***Amendments***

***Remarks***

Fig. 1

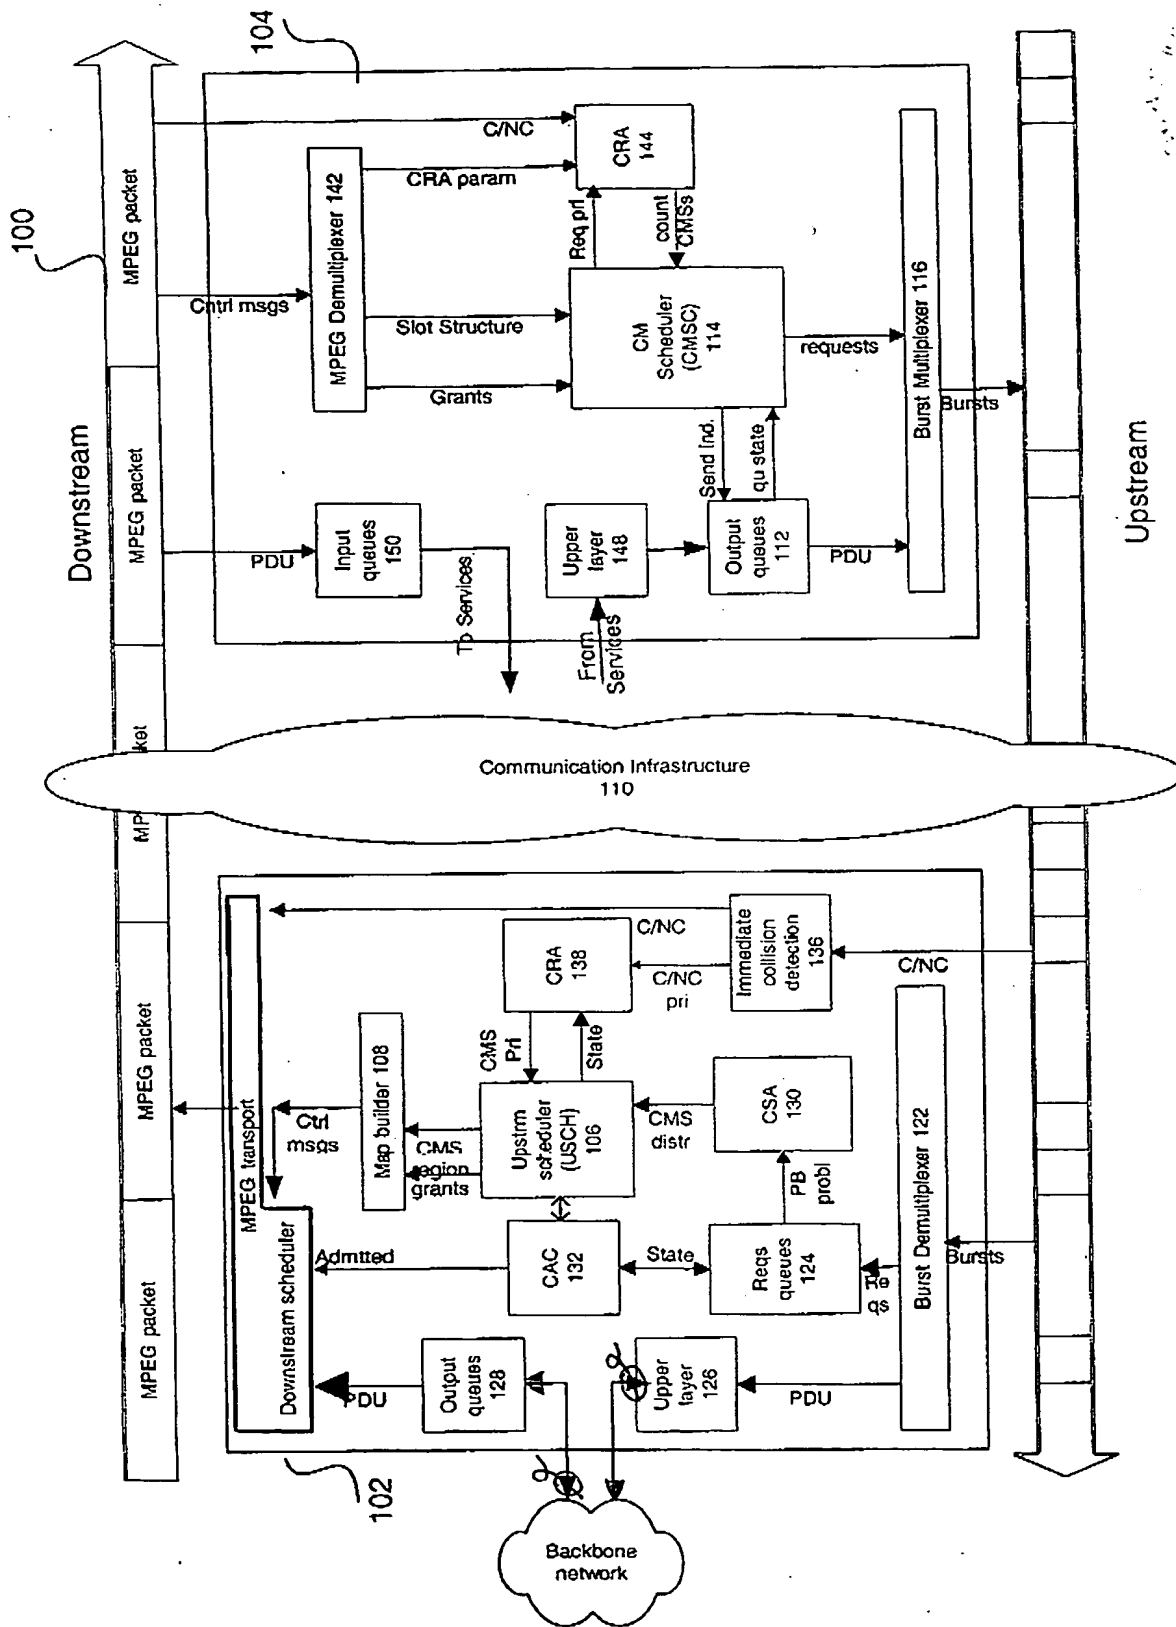
Applicants respectfully request approval of the proposed drawing changes provided herewith and illustrated in more detail in red ink on the attached Markup Copy of Figure 1. The changes to the drawing are made to rectify three obvious errors as illustrated in red ink. The first two errors pertain to the directional arrows shown therein. Referring to the pending Figure 1, Applicants assert that (1) the arrow connecting element "Upper Layer 126" to element "Backbone Network", and (2) the arrow connecting element "Backbone Network" to element "Output Queues 128" both are positioned incorrectly to depict the functional relationship among the elements. In the pending Figure 1, these arrows are reversed in the incorrect direction. Applicants further assert that no other direction for these arrows could have been intended. Therefore in the attached Figure 1, Applicants have illustrated the above-mentioned arrows in the correct

direction. The Applicants' assertions are clearly supported by the specification in paragraph 21 which describes the interrelationship of the aforementioned elements.

In addition, Applicants assert that a box outlining the element "Downstream Scheduler / MPEG Transport" is missing erroneously although the text "Downstream Scheduler / MPEG Transport" is present to label the missing box. Applicants note that several correctly boxed elements (such as, "128," "132," "108," and "136") have arrows pointing towards the element "Downstream Scheduler / MPEG Transport" to indicate the flow of signals thereto, and the element "Downstream Scheduler / MPEG Transport" also has an arrow pointing towards the element "Downstream Channel" to indicate the flow of signals thereto. Referring to the attached Figure 1, Applicants have illustrated a box to outline the element "Downstream Scheduler / MPEG Transport." The Applicants' assertions are clearly supported by paragraphs 30, 31, 32, 34, and 35 within the specification.

Please substitute the attached Figure 1 for the pending Figure 1. The attached Figure 1 is a duplicate of the drawing that is being submitted herewith as part of the Formal Drawings for Figures 1-4. The Formal Drawings are being submitted herewith under a separate pleading for approval.
